MEMORANDUM

RE: **#88-20 Discussion and review relative to the draft Zoning Ordinance**
DIRECTOR OF PLANNING requesting review, discussion, and direction relative to the draft Zoning Ordinance.
Other docket items to be taken up within the context of Zoning Redesign include #30-20, #38-20, and #148-20

Attachment B**Staff Responses to Past Questions from Councilors Regarding Garage Ordinance, Driveways, and Parking Requirements**

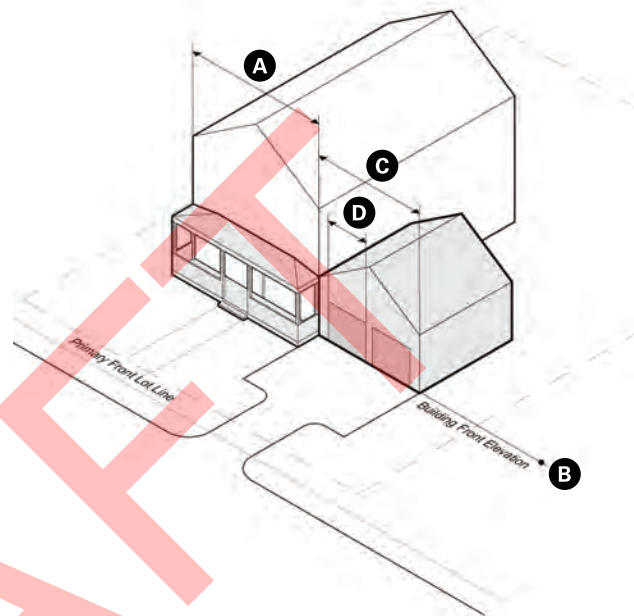
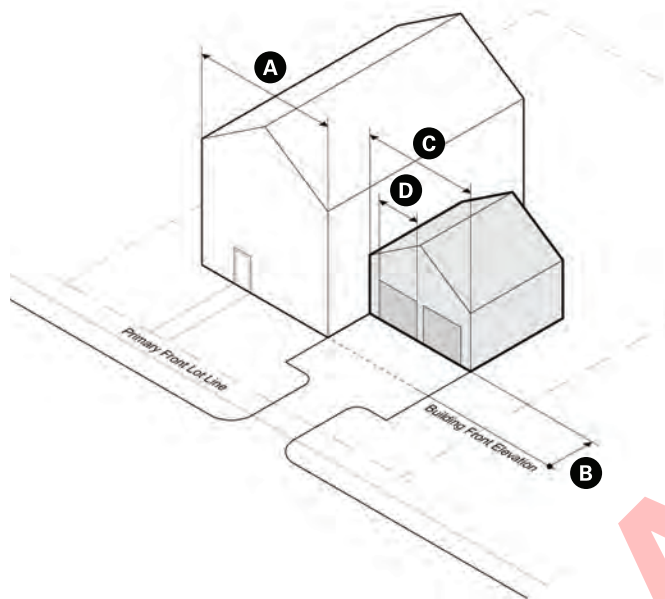
Q: Section 3.4.2.D claims that a garage set back 10' from front elevation and may not exceed 50% of the building front. This is good design practice when the front door takes precedence. How was 10' chosen? Is this a standard?

A: The latest draft recommends that a Front Facing Garage be set back a minimum of 8 ft from the Front Elevation (Sec. 3.4.2.D.a), which aligns with the standard requirements for the Side Wing Building Component. This is not a standard per se. The requirement to offset the garage from the Front Elevation of the building is to limit the visual impact. This recommendation was reviewed by the local architects and builders group.

Lot with eight residential units or less

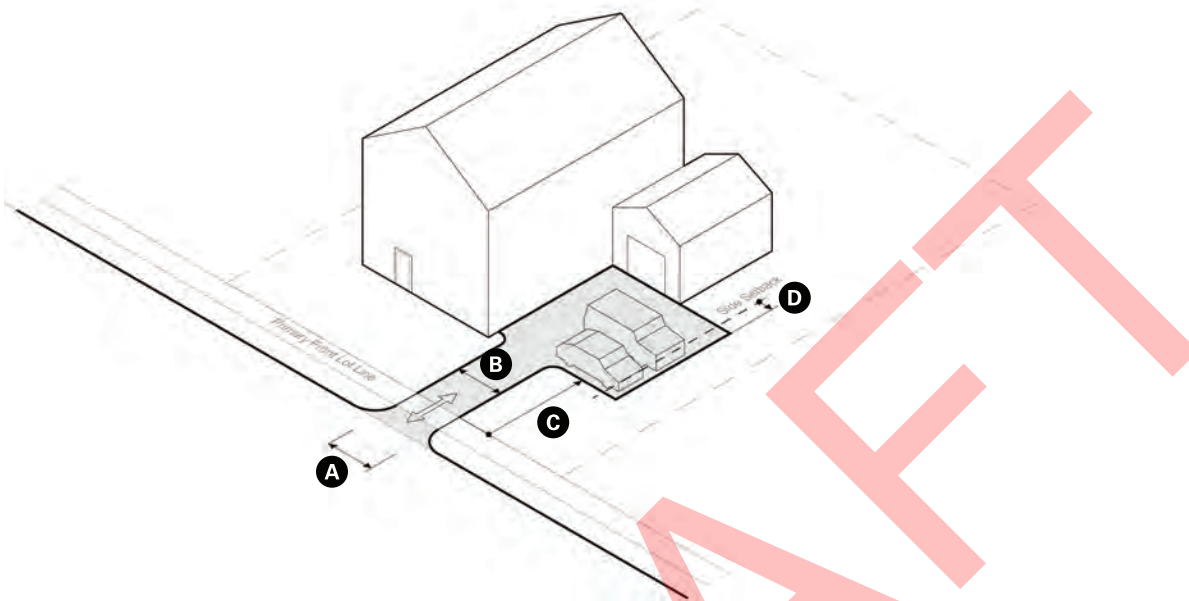
Q: My understanding is that you are recommending that the entrance to a driveway be no greater than 10 feet at the entrance and that this 10 foot width be extended 10 feet into the property from the edge of the sidewalk nearest the property line. Is that correct?

Q: Section 3.7.1.E.7 says that 2 curb cuts have to be 35’ away from each other. Where did the number 35’ come from? Is this a standard?

A: The latest draft recommends that one-way driveways be restricted to a maximum of 10 feet at the property line and for 10 feet beyond the property line into the site for properties in the R1 and R2 districts. Because of the smaller front setback requirements in R3, R4, and N the proposed distance is reduced to 5 feet beyond the property line. The property line does always correspond to the edge of the sidewalk. The curb cut is restricted to a maximum of 12 feet for one way-driveways.

A: Note: In the latest draft this refers to Sec. 3.7.1.E.8. The 35-foot distance between two curb cuts was provided by our consultant and reviewed by ISD and Engineering. 35 feet allows for two standard cars to be parked between the two curb cuts and it provides a sizeable “safe zone” for pedestrians between each curb cut.
